Morecambe Offshore Windfarm: Generation Assets Examination Documents

The Applicant's Response to ExA's Written Questions 3GEN2 and 3GEN3

Document Reference: 9.61.1

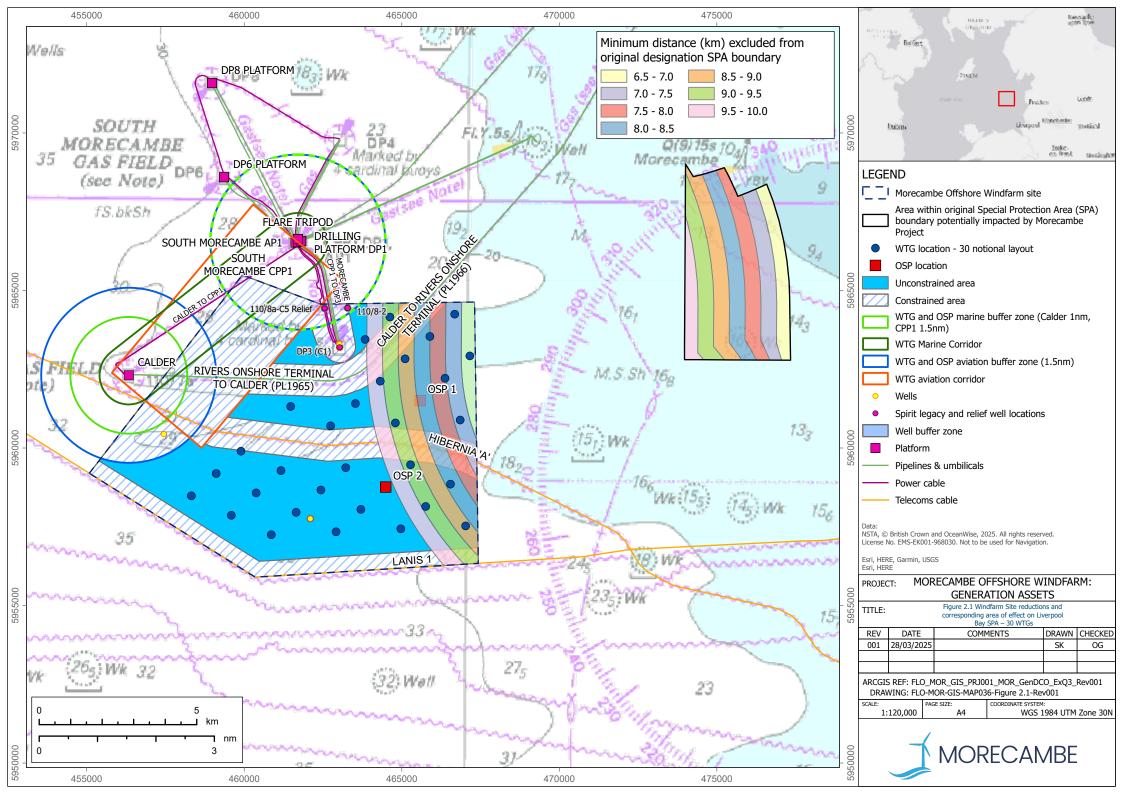
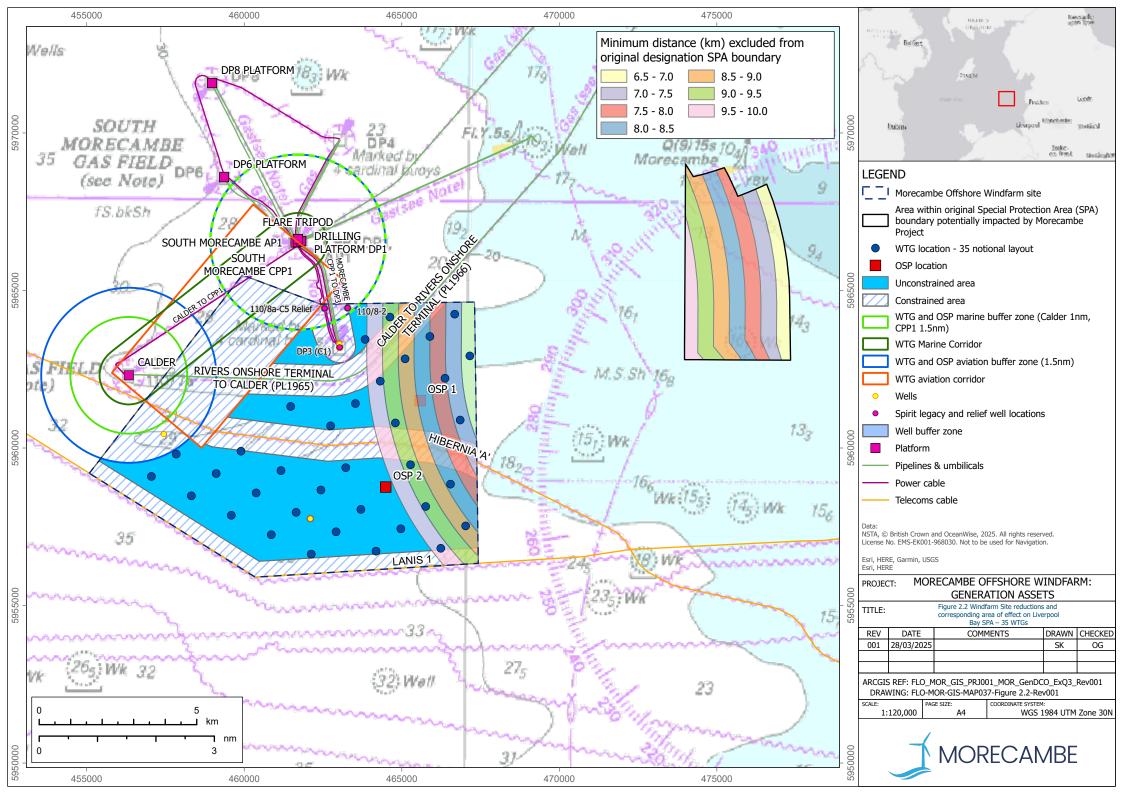
- 6. For ease of reference, 3GEN3b is provided here:
 - 'b) can the applicant please provide further explanation or evidence to support its position that the potential loss of a single WTG as result of a 7km buffer from the original Liverpool Bay SPA (or any other reduction in WTG numbers) would affect the viability of the proposed development?'

- 10. **Figure 2.1** and **Figure 2.2** show different buffer zones in 500m increments from the boundary of the original Liverpool Bay SPA. As can be seen, for the 35 turbine notional layout (**Figure 2.2**) a 7km buffer results in the loss of one turbine location and a 10km buffer results in the loss of 14 turbine locations (this is a visual representation of what was described in response to 2HRA6). Note the reference to a 7km buffer means the area shown as the 6.5km 7km area within the wind farm site coloured light green on **Figure 2.1** and **Figure 2.2**. The Windfarm Site is already located 6.5km from the SPA so a 6.5km buffer is an inherent part of the site selection.

- As noted above, the results of the analysis of potential boundary reduction in 500m increments from 7km to 10km are presented in **Figure 2.1** and **Figure 2.2**. Further detail is provided within **Table 2.1**. This confirms that the total area of effect would reduce from 17.99km² (the area of the SPA impacted with the Application Order Limits boundary, as presented in the RIAA (Document Reference 4.9)) to 15.72km² with a 7km buffer, and then reduces sequentially to 1.53km² with a 9.5km buffer. This area of impact is equivalent to 0.92% to 0.09% of the original SPA boundary (compared to 1.06% with the Application Order Limits boundary).
- 29. Taking into account the displacement gradient, the effective area of displacement with a 7km buffer would be 5.46km² (0.32% of the original SPA),

- 17. As such there is no scope to further narrow the PDE or finalise the layout at this time, and the envelope of up to 35 turbines as shown on the Figure 2.2 remains appropriate, meaning that even a 7km buffer will result in the loss of at least one turbine location from the notional layout. It would also restrict the opportunity for further design optimisation and design efficiencies at the detailed design stage, meaning that, in practice, it may result in the loss of additional turbine locations.

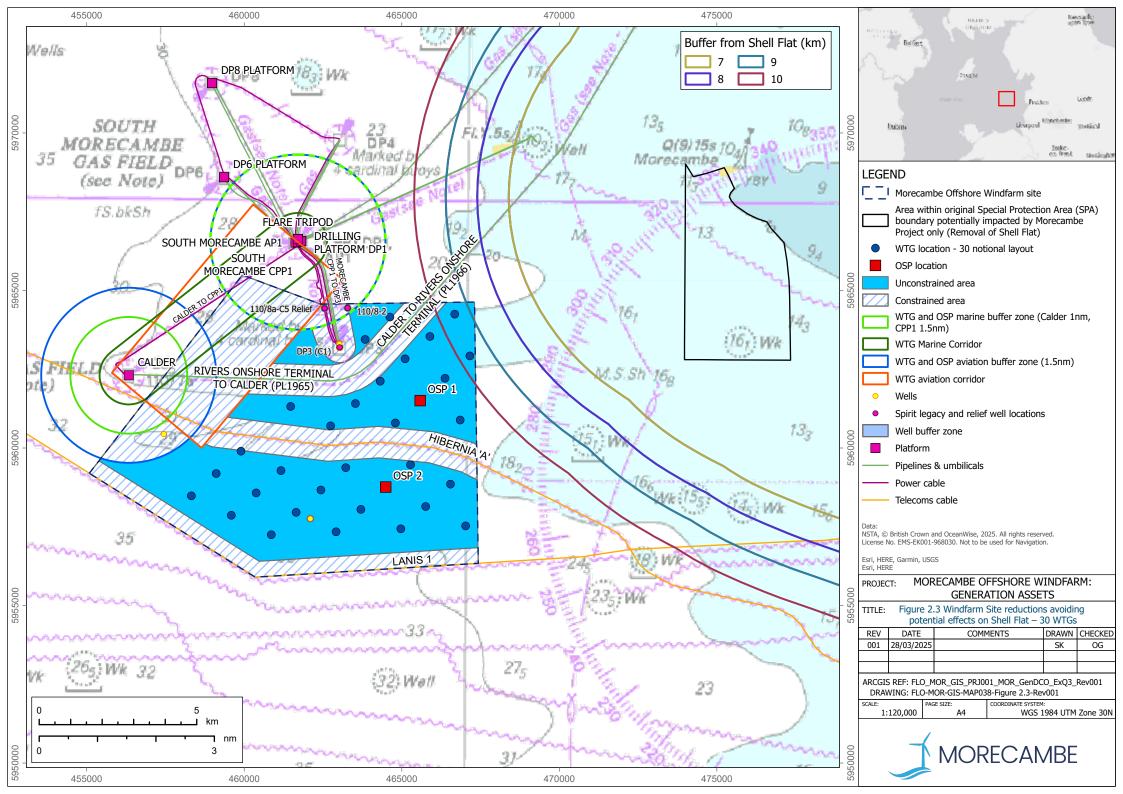
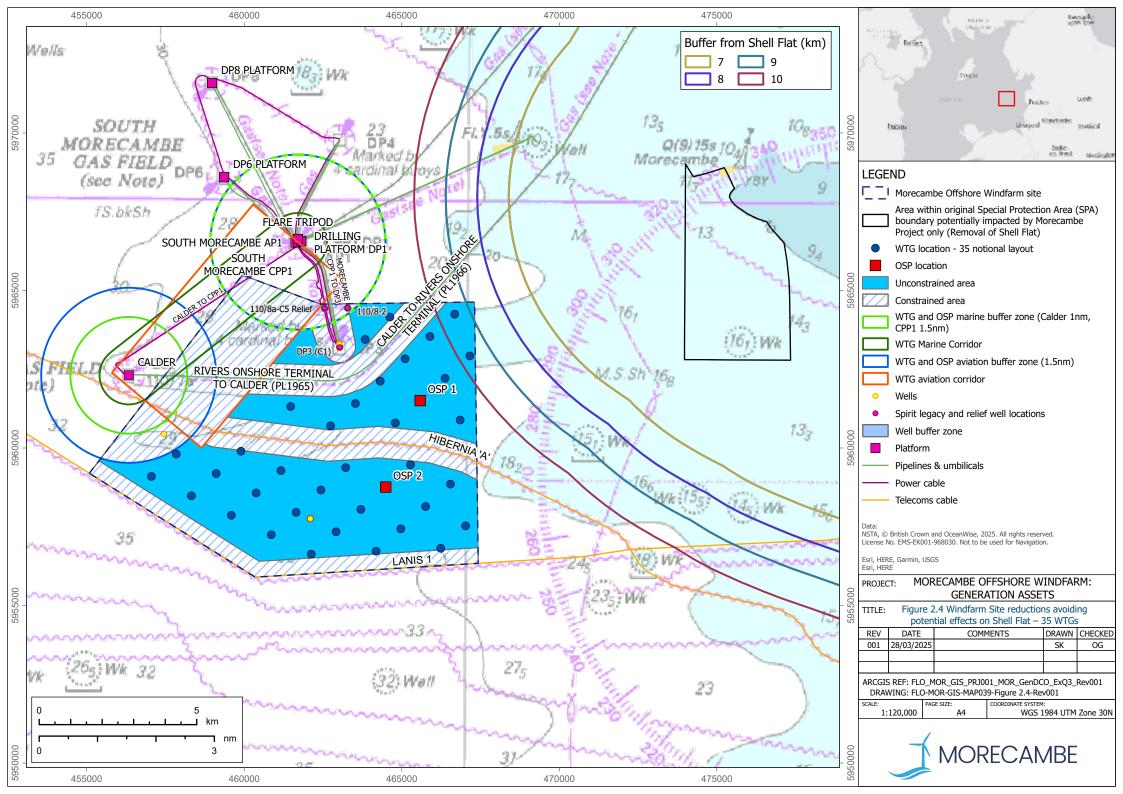
- 30. Through discussion with NE the Applicant has been requested to consider the implications of buffers around the most sensitive parts of the Liverpool Bay SPA; including on Shell Flat, an area of sandbank habitat covered by shallow water which is designated as a Special Area of Conservation but it also entirely within the Liverpool Bay SPA.
- 31. The exclusion of a potential effect on Shell Flat is shown on **Figure 2.3** and **Figure 2.4**, and would reduce the area of effect within the original SPA boundary to 16.77km² (0.98%). However, the area of effect is less relevant in this context, as effects on the area of importance (i.e. Shell Flat) would be entirely avoided. A 10km buffer would result in the loss of between one and two notional WTGs from either layout presented, while a 9km buffer could be accommodated without any notional WTG loss.
